HILLSIDE AT LORSON
 RANCH
 EL PASO COUNTY, CO
 LORSON RANCH METRO
 DIST. NO. 1

**SUBEXCAVATION
 RECOMMENDATIONS**

SHEET No.
FIG-88

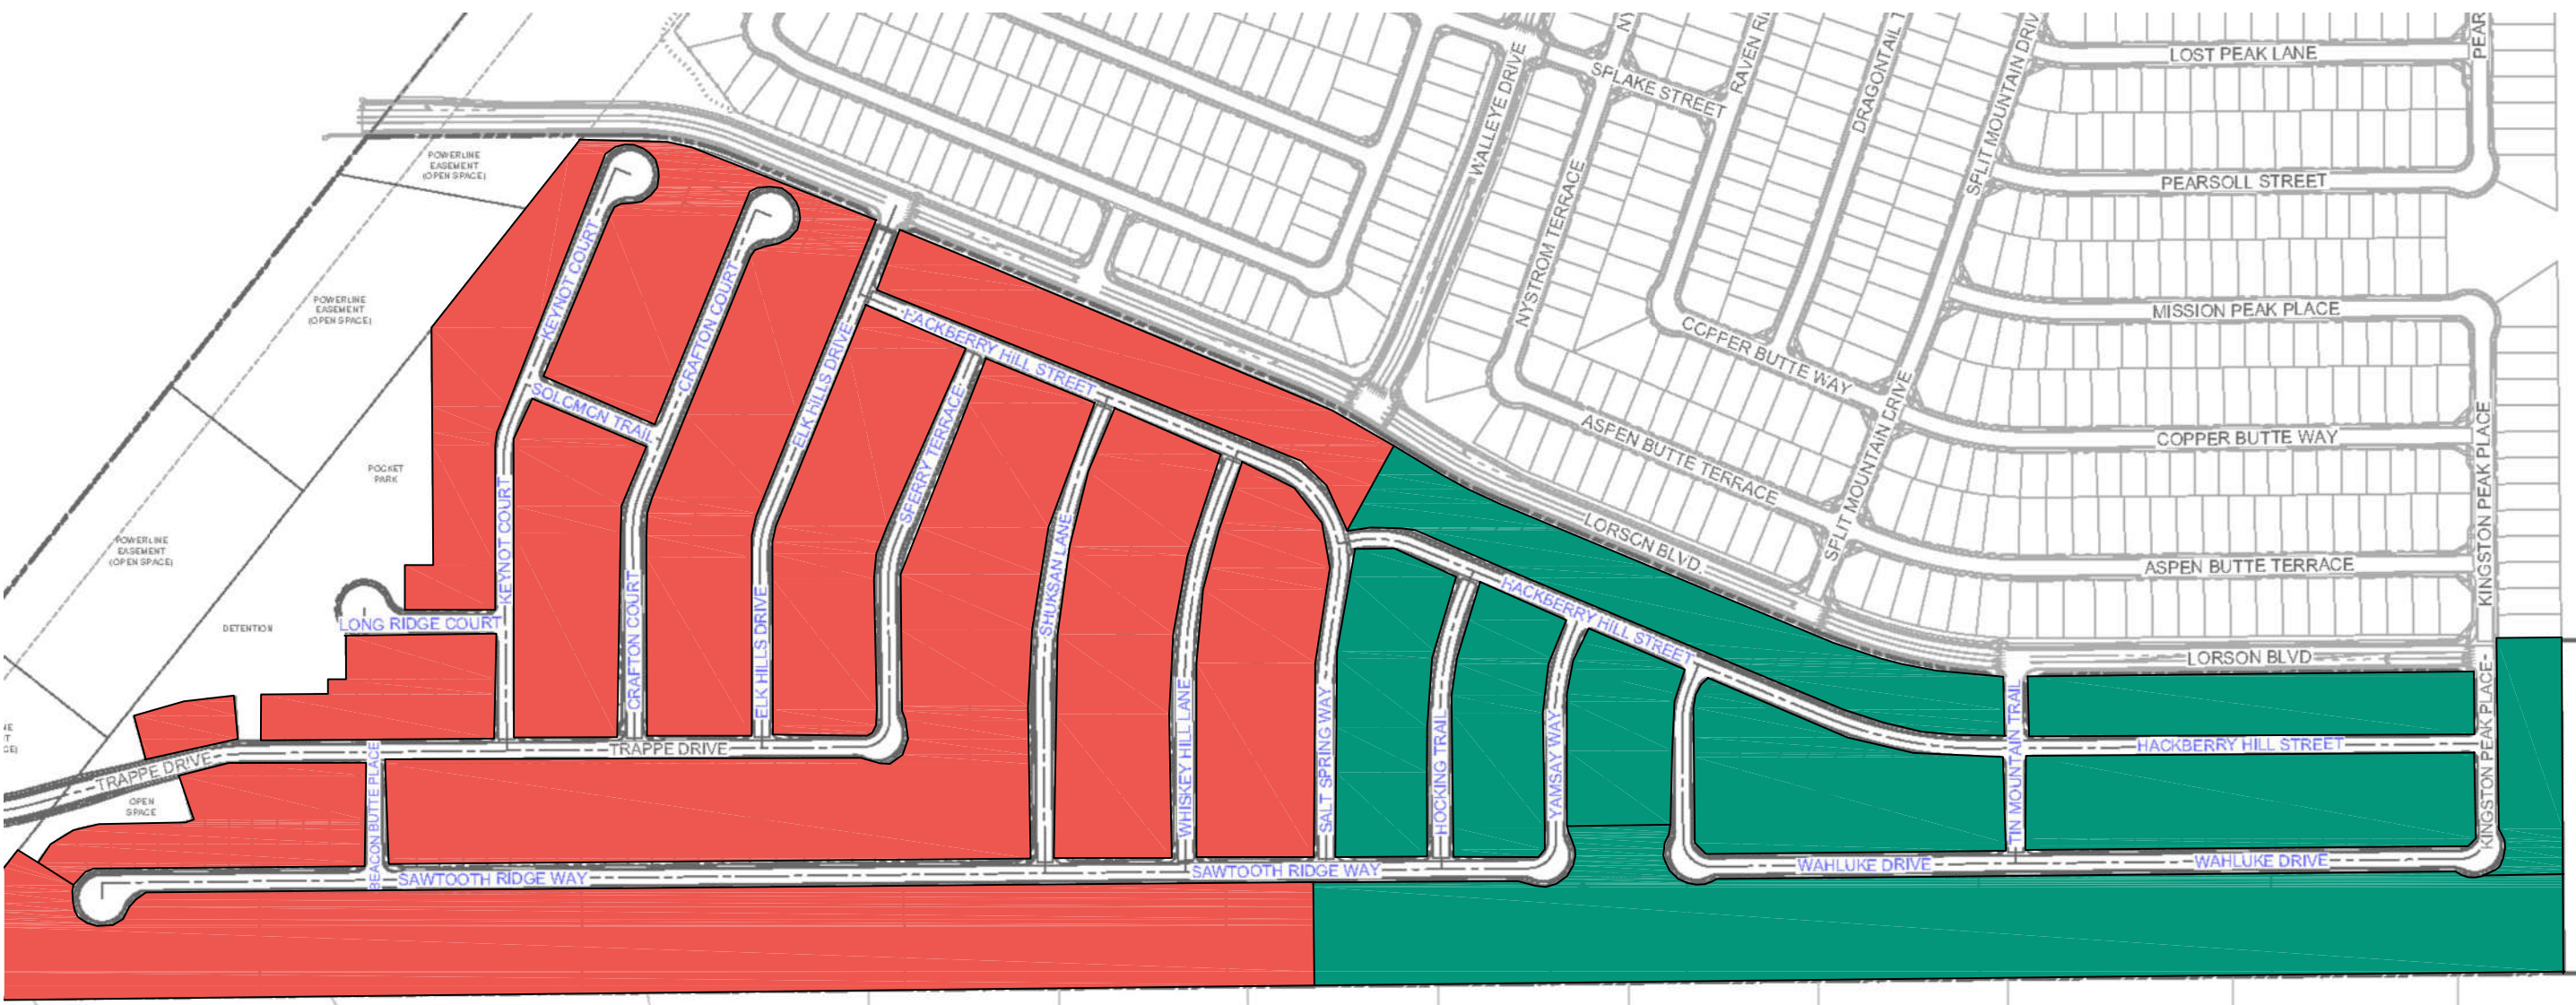
are these
backwards?
